**26-C CONTROL VALVE SERVICE PORTION****PART NOS. 567143, 567496, 586930, 592167****EMERGENCY LIMITING VALVE****Spring, Wasp Excluder and Cap Nut Replacement**

JANUARY, 1997

**Figure 1 - Part No. 92491**  
**Previous Emergency Limiting Valve Spring**

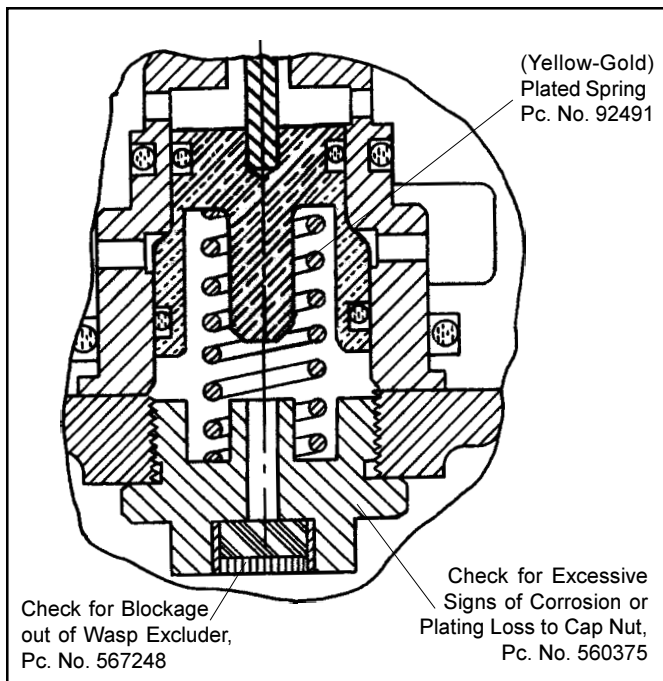
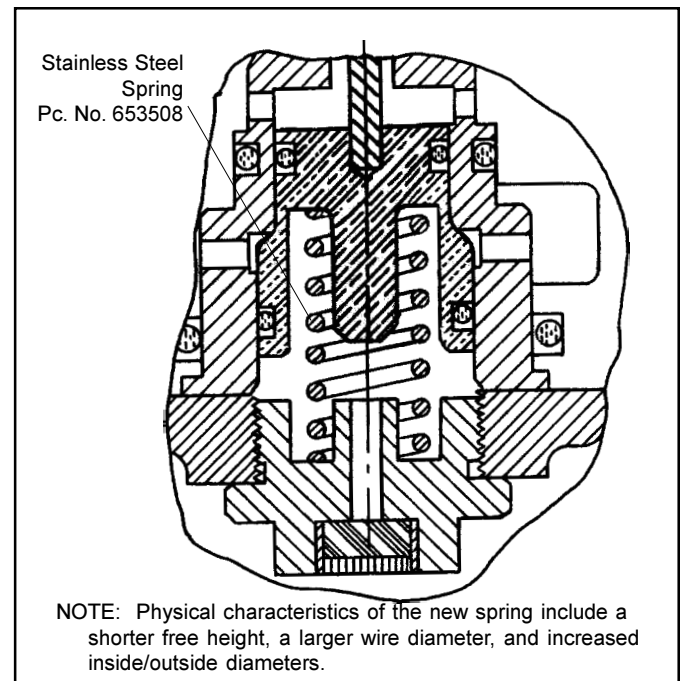
The Emergency Limiting Valve Spring (Part No. 92491) used in the 26-C Control Valve Service Portions has been replaced with a new Stainless Steel Spring (Part No. 653508). This new spring must be installed during the next scheduled C.O.T. In addition, the 26-C Control Valve Emergency Limiting Valve Cap Nut (Part No. 560375) should be examined. Replacement of wasp excluder (Part No. 567248) in the cap nut is necessary if blockage exists. Blockage is evidenced by failing to allow air to vent out of the wasp excluder's passages. Replacement of the cap nut may be necessary if excessive corrosion or plating loss is present. Note: wasp excluder (Part No. 567248) is part of the cap nut assembly (Part No. 560375).

**Figure 2 - Part No. 653508**  
**New Stainless Steel Emergency  
 Limiting Valve Spring**
